City of Bixby Planning Commission Meeting Agenda

Monday, July 15, 2024

To: Planning Commission

RE: **SITE PLAN | (BXSP-24.08) MARLEE OFFICE NO. 5**
Applicant | W Design, Darshan Patel

EXISTING UTILITIES

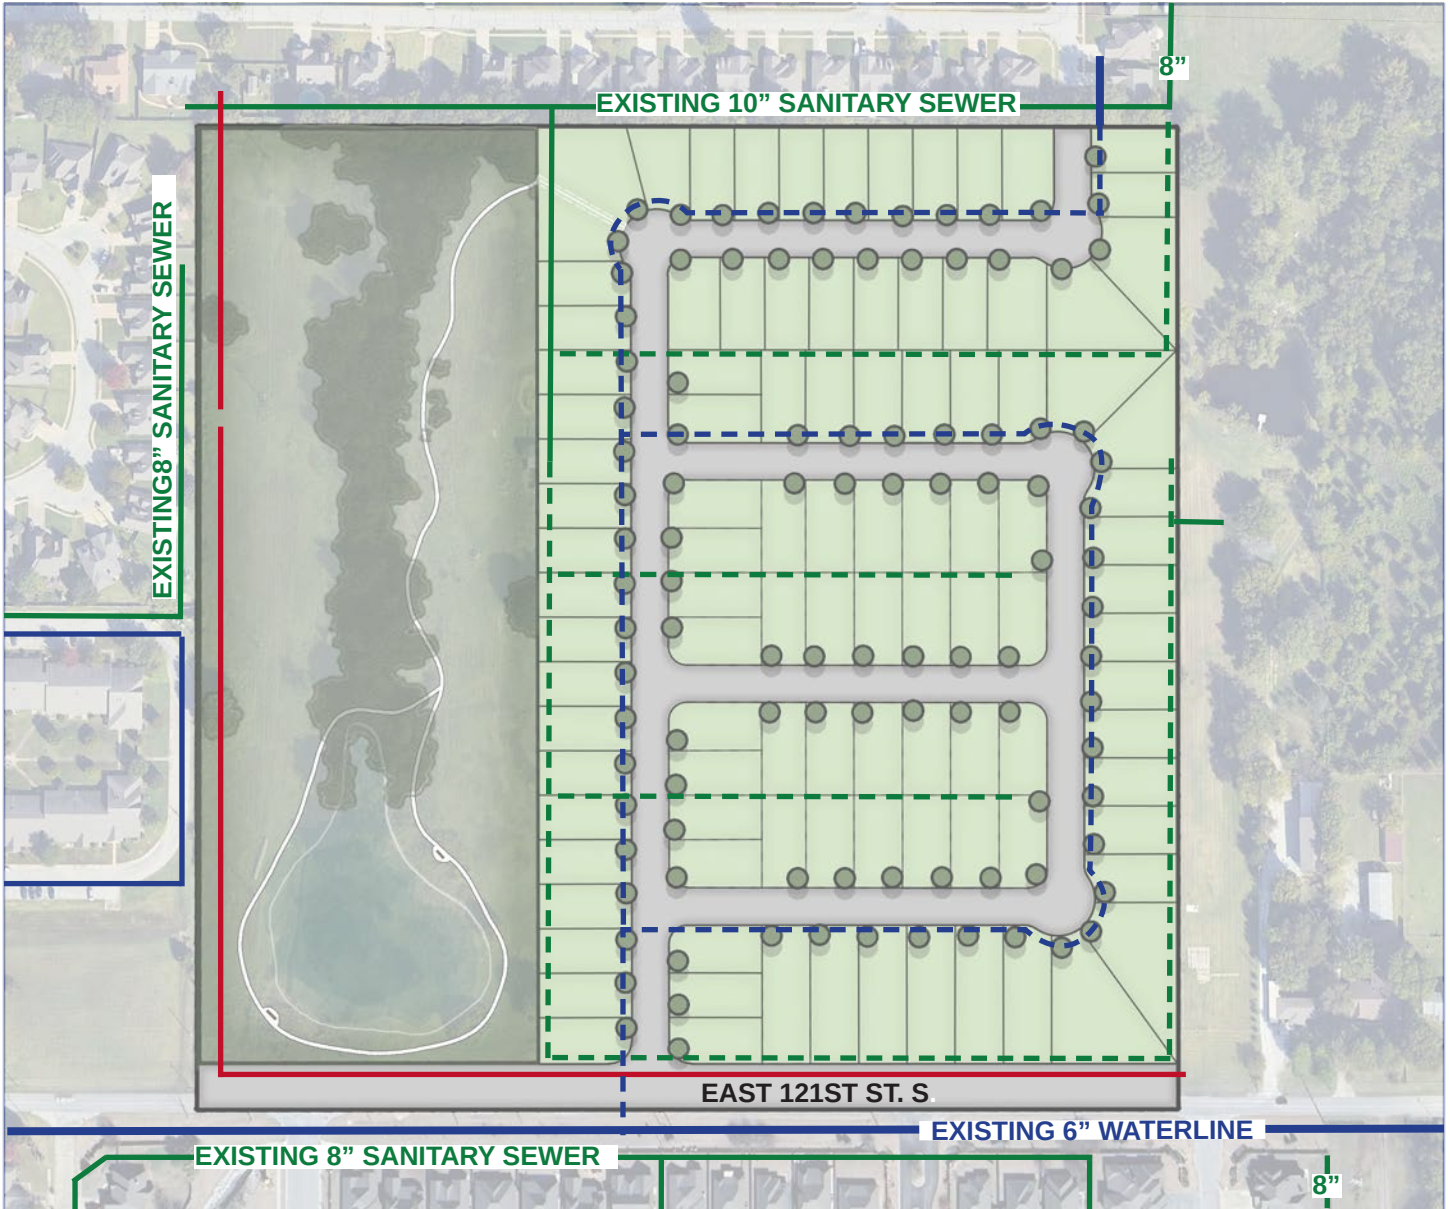
9. The PUD should discuss landscaping requirements on each lot.
10. The PUD exhibit for proposed utilities does not provide water to the middle block of the subdivision. This exhibit should be updated and the PUD resubmitted.

DRAFT FINAL PLAT

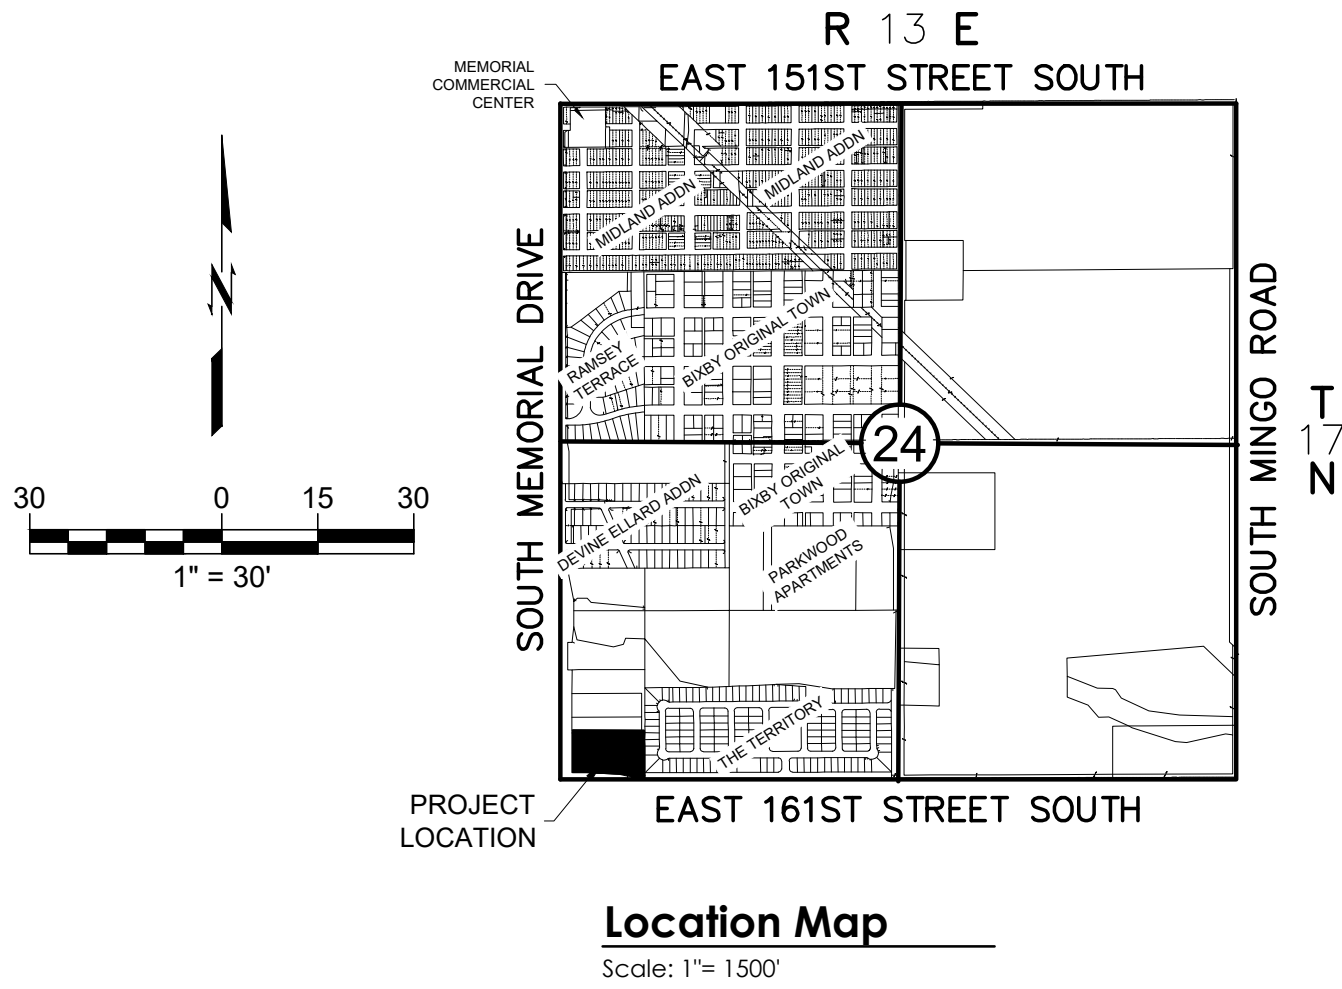
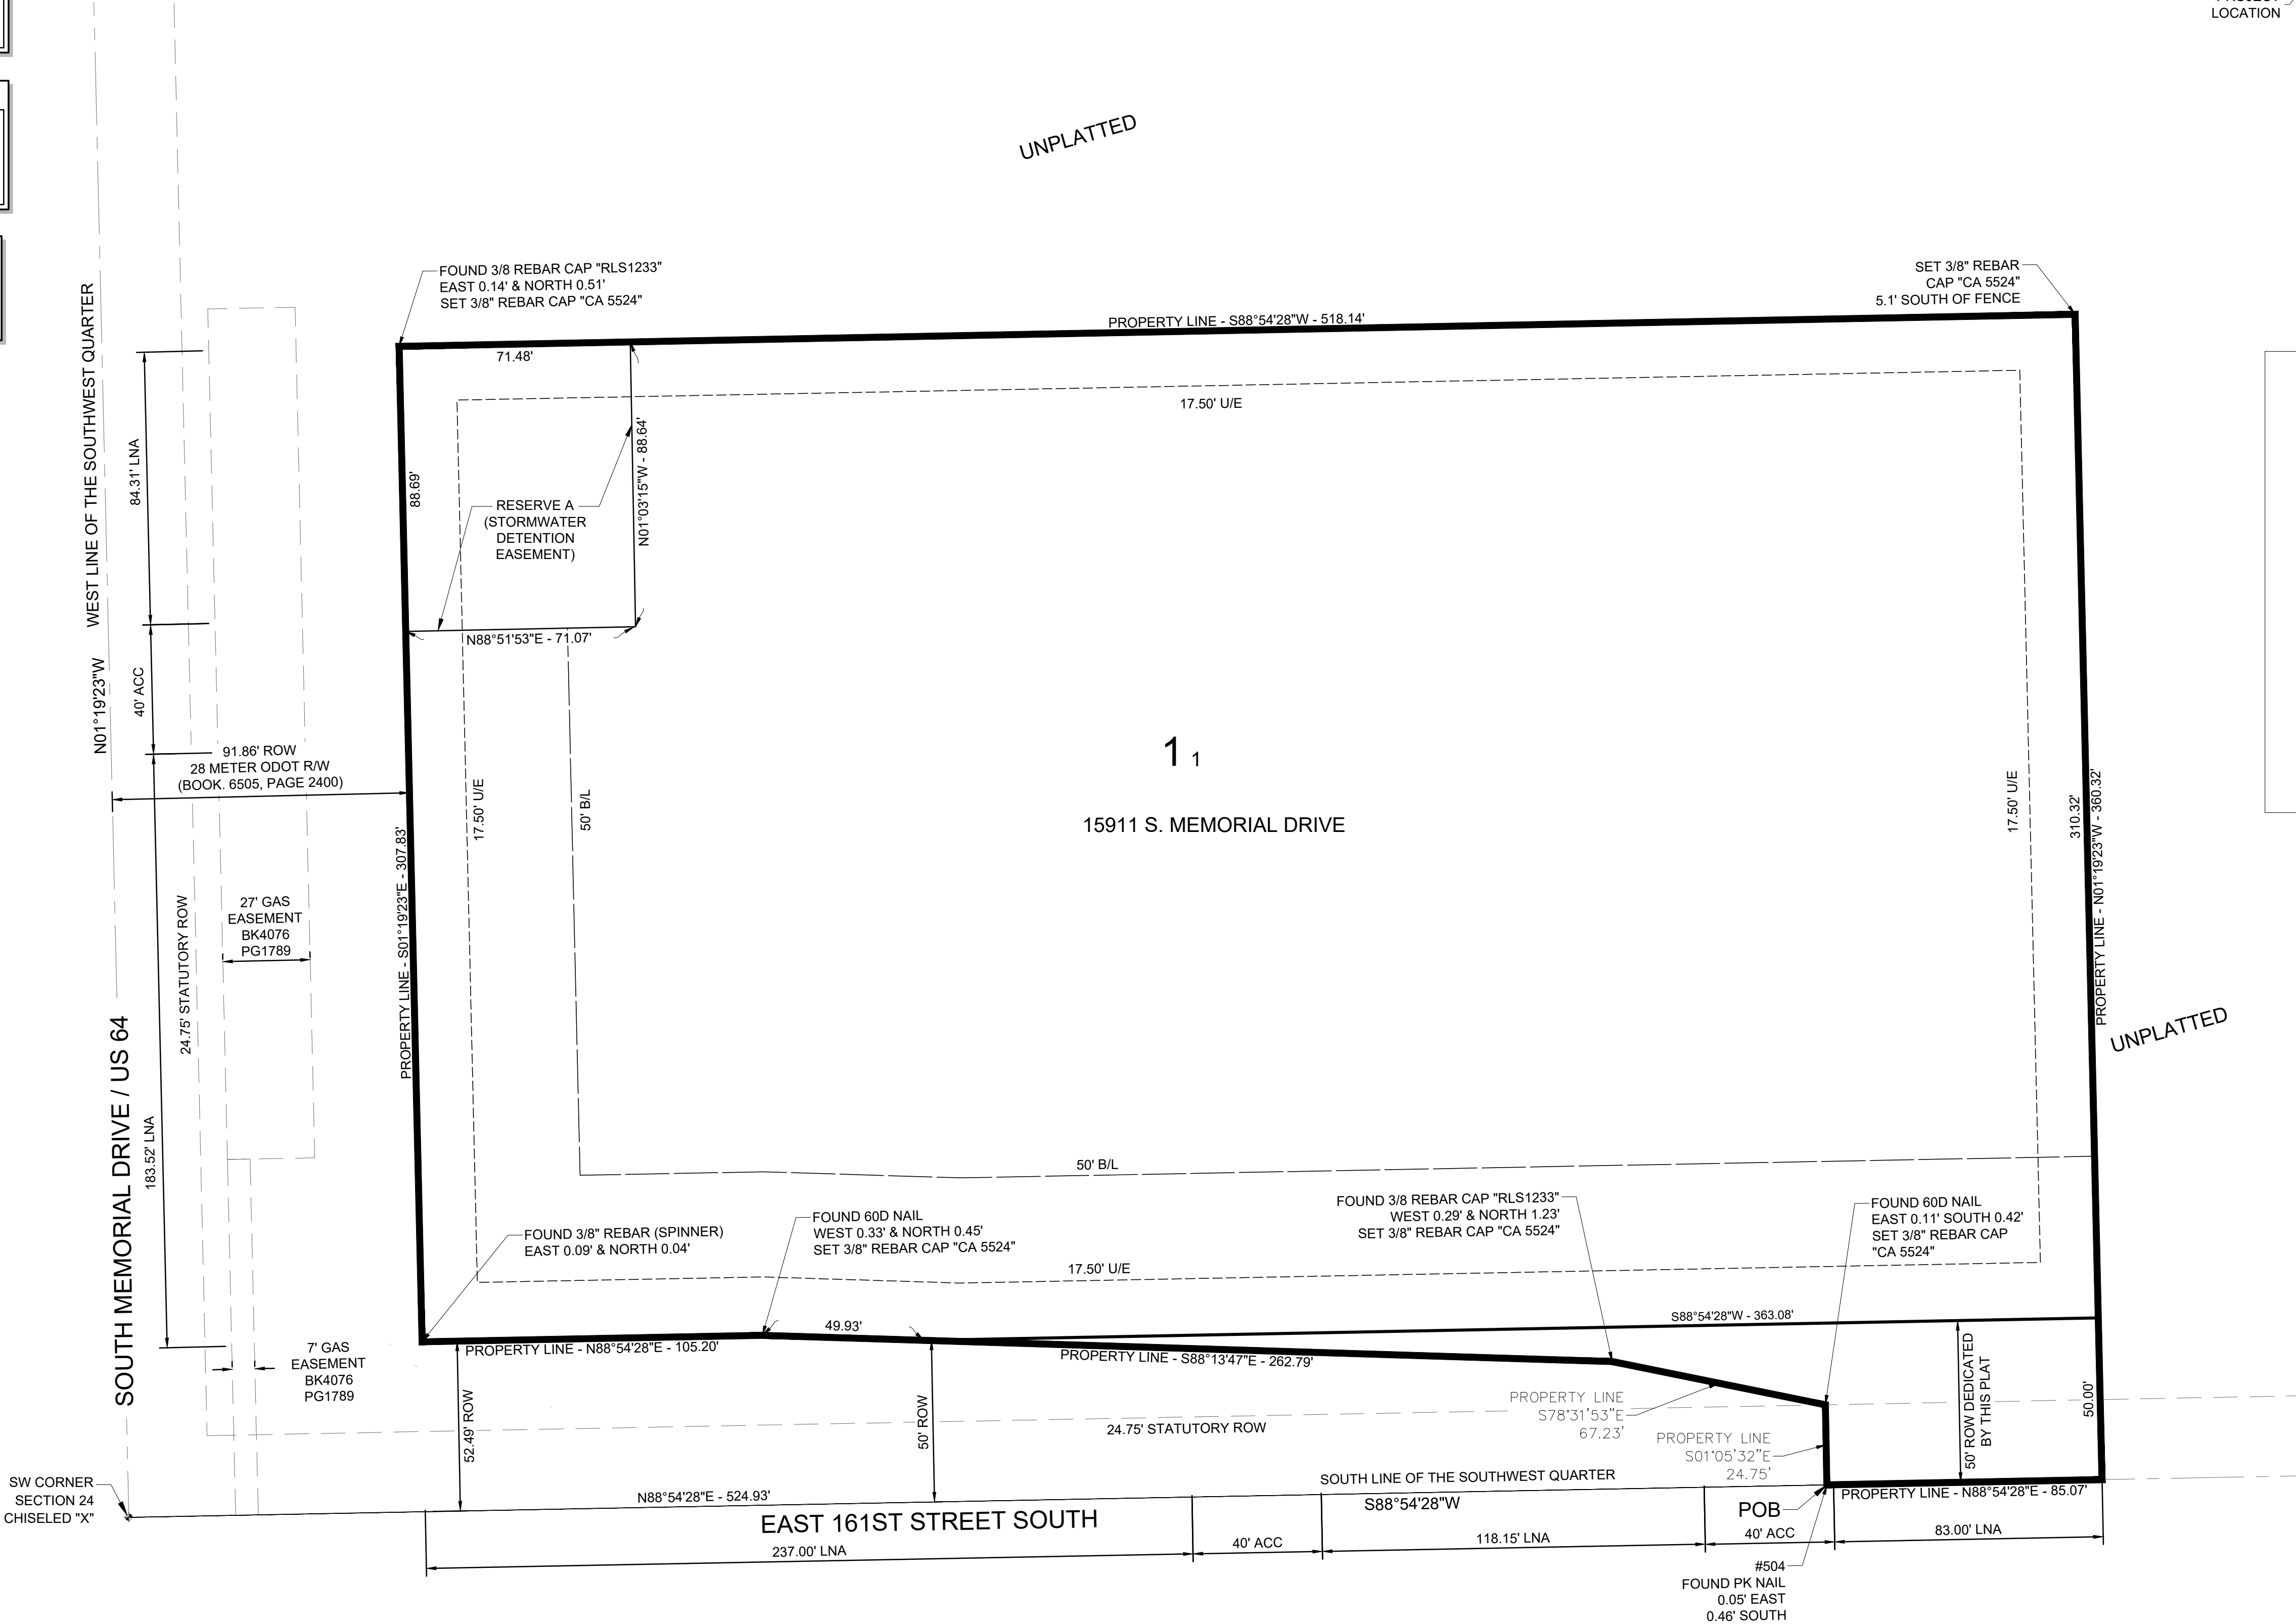
- Per Bixby's Engineering Design Manual, detention areas must be included within reserve areas. The drainage easement area should be converted to a reserve area, and the associated maintenance requirements should be included within the reserve area language.
- The Final Plat's Deed of Dedication (DoD) only discussed the maintenance of public storm sewers. The word "Public" should be included before "Storm Sewer," and the DoD should include language discussing the maintenance of private storm sewers.
- The appropriate building limit line should be added to the North and East property lines.
